### STAFF REPORT: REGULAR CALENDAR

**APPLICATION NO.:** 4-97-236

**APPLICANT:** NOAS Properties, Inc.

**PROJECT DESCRIPTION:** Removal of an unpermitted rock revetment and construction of new 50 foot long by 19 foot wide by 10 foot high rock revetment fronting an existing timber bulkhead. The proposed revetment consists of a 2 foot layer of drain rock (3/4 to 6" size) at a design depth of 0.0 mean sea level (MSL), a 1-2 foot layer of "B" stone (200 pounds to 1,200 pounds) and cap stone (2 to 7 tons) placed over the filter rock and "B" stone layers.

**SECTION "A-A" - REPAIRED REV'TMENT**  
SCALE: 1/4" = 1'

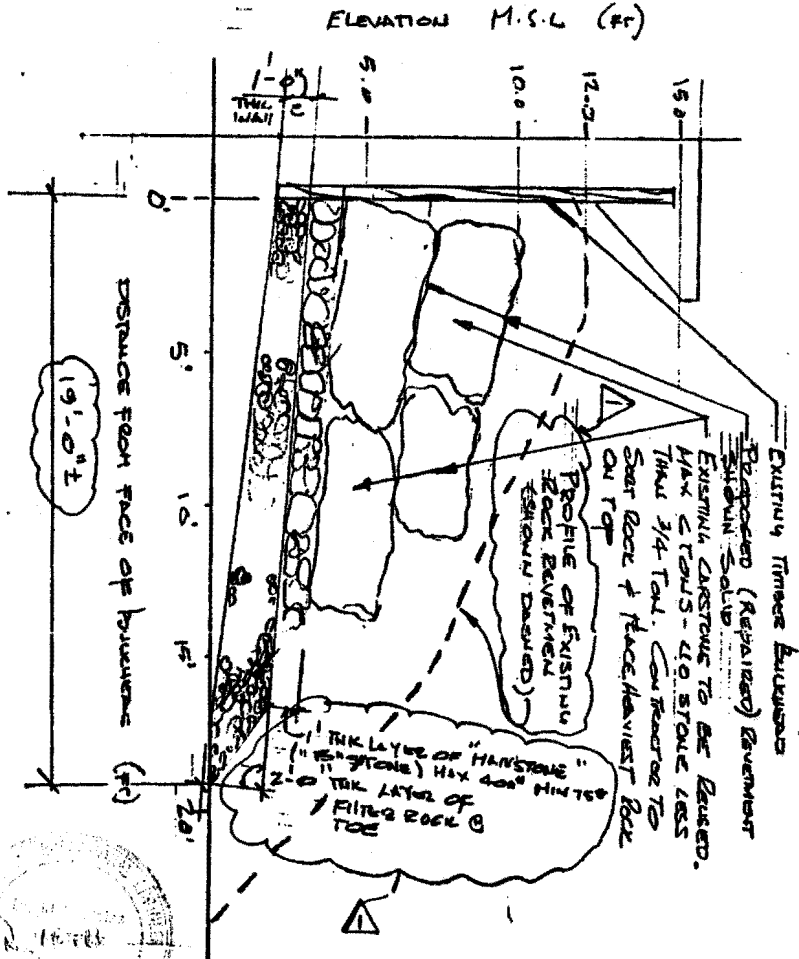
The applicant is proposing the removal of an unpermitted revetment and construction of a new 50 ft. long, 10 ft. high (max. ht. from 0.0 msl), 19 ft. wide rock revetment in front of an existing timber bulkhead. The revetment consists of a 2 foot layer of drain rock (3/4 to 6"size) at a design depth of 0.0 mean sea level (MSL), a 1-2 foot layer of "B" stone (200 pounds to 1,200 pounds) and cap stone (2 to 7 tons) placed over the filter rock and "B" stone layers. The proposed revetment is designed to prevent scour below the existing timber bulkhead which was not designed at an adequate depth to prevent scour under the bulkhead (Exhibit 3)

The proposed project involves the removal of an unpermitted revetment and construction of a new 50 ft. long, 10 ft. high (max. ht. from 0.0 msl), 19 ft. wide rock revetment in front of an existing timber bulkhead. The revetment consists of a 2 foot layer of drain rock (3/4" to 6" size) at a design depth of 0.0 mean sea level (MSL), a 1-2 foot layer of "B" stone (200 pounds to 1,200 pounds) and cap stone (2 to 7 tons) placed over the filter rock and "B" stone layers (Exhibit 3). The proposed revetment is designed to prevent scour below the existing timber bulkhead. The existing bulkhead was not designed at an adequate depth to prevent scour under the bulkhead. The existing residence on the site is setback only six (6) feet from existing bulkhead and is on a conventional at grade foundation (Exhibit 2). The loss of fill or sand from behind the bulkhead would result in damage to the existing residence by undermining the foundation. In addition, neighboring properties could also be adversely effected by the loss of fill or sand under the bulkhead. The proposed revetment is smaller than the existing unpermitted revetment which extended approximately 25 feet from the face of the existing timber bulkhead and reached a height of approximately 12 feet above MSL.

In this case, there are three alternative bulkhead repair or upgrade designs that would minimize encroachment of the protective device seaward and prevent scouring below the existing bulkhead. The first alternative involves the addition of timber sheathing to the existing bulkhead below the design scour depth of the beach. The second design alternative is a poured in place concrete underpin wall located directly below the existing bulkhead which would extend below the design scour level of the beach. The third alternative involves the installation of sheet pile attached to landward side of the bulkhead extending below the scour depth of the beach. All of these alternatives would prevent scour below the existing bulkhead and would eliminate the need for a rock revetment that extends a considerable distance seaward of the existing bulkhead.

As discussed above, the addition of a protective rock revetment seaward of the existing bulkhead will over time have an adverse impact on the profile and sand supply of this beach. To minimize the adverse impacts associated with shoreline protective devices the Commission has required in past permit actions that the shoreline protective structure be sited as far landward as feasible. In this case there are three alternatives to the proposed revetment which would not require the seaward encroachment of the protective device. These alternatives include; (1) the addition of timber sheathing to the existing bulkhead below the design scour depth of the beach; (2) the construction of a poured in place concrete undepin wall beneath the existing bulkhead to a depth below the design scour depth of the beach; and (3) the installation of sheet pile behind and attached to the existing bulkhead extending below the design scour depth of the beach.

**Exhibit 7**  
**Photograph of Existing**  
**Bulkhead and**  
**Unpermitted Rock**  
**Revetment**

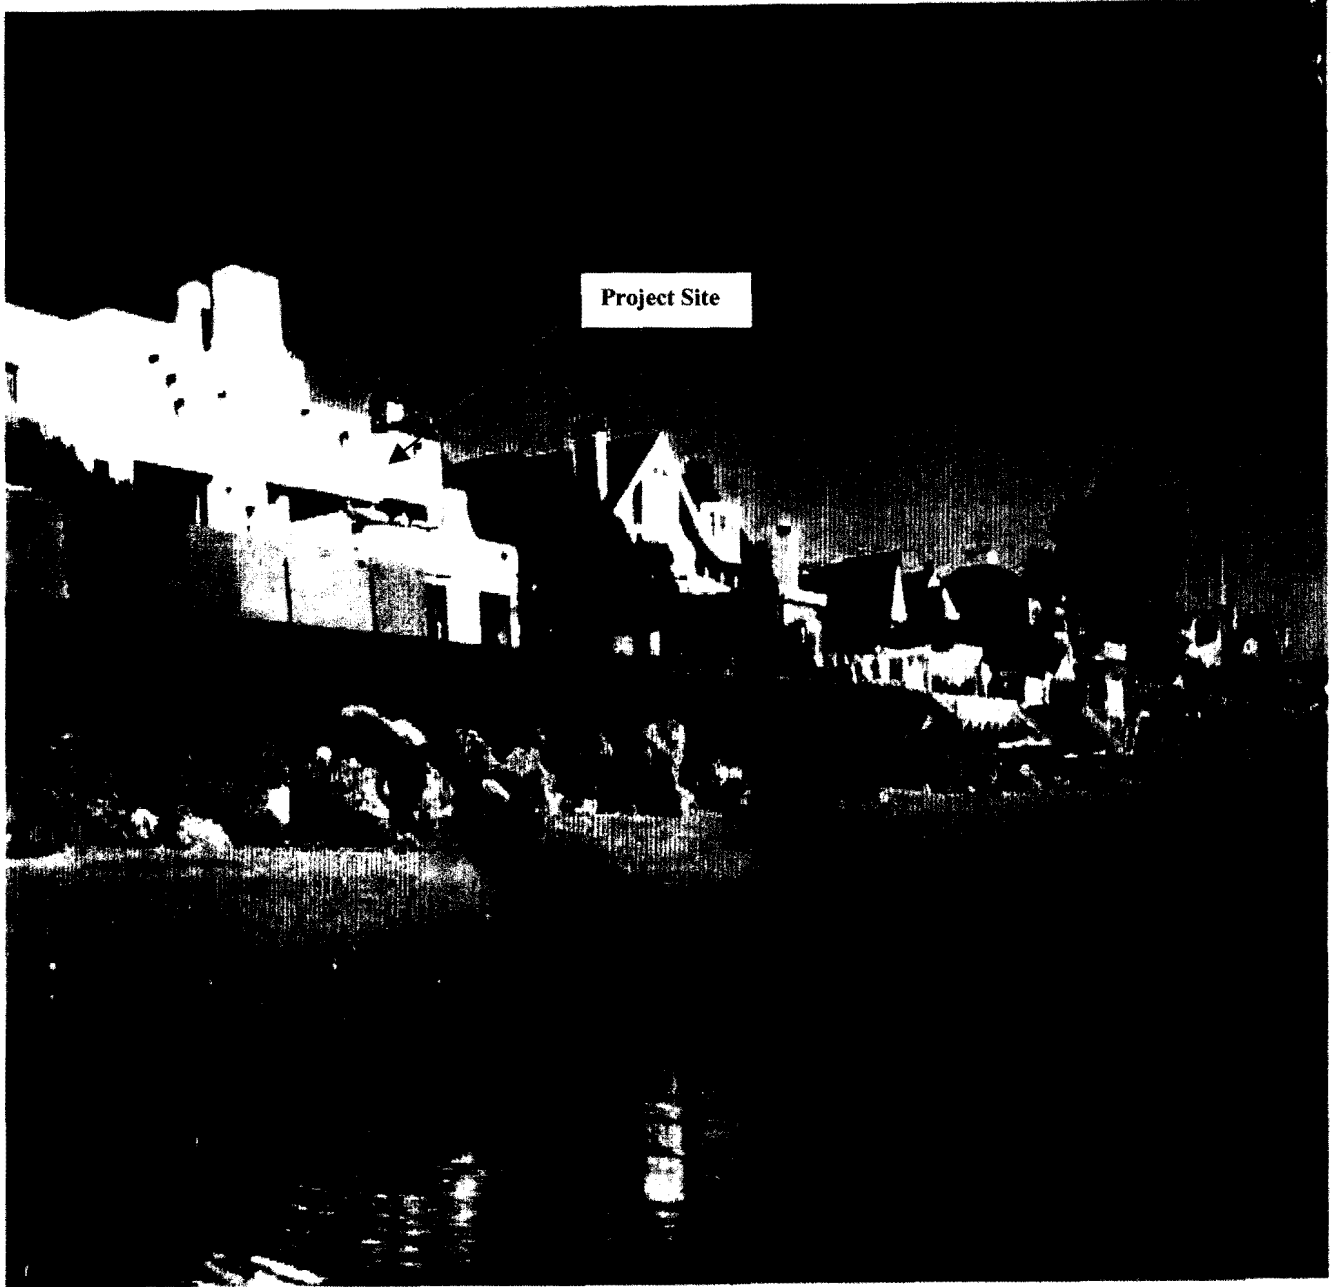
The existing rock revetment on the site was constructed without a coastal development permit. Consideration of this application by the Commission has been based solely upon the Chapter 3 policies of the Coastal Act. Review of this permit does not constitute a waiver of any legal action with regard to the alleged violation nor does it constitute an admission as to the legality of any development undertaken on the subject site without a coastal permit.
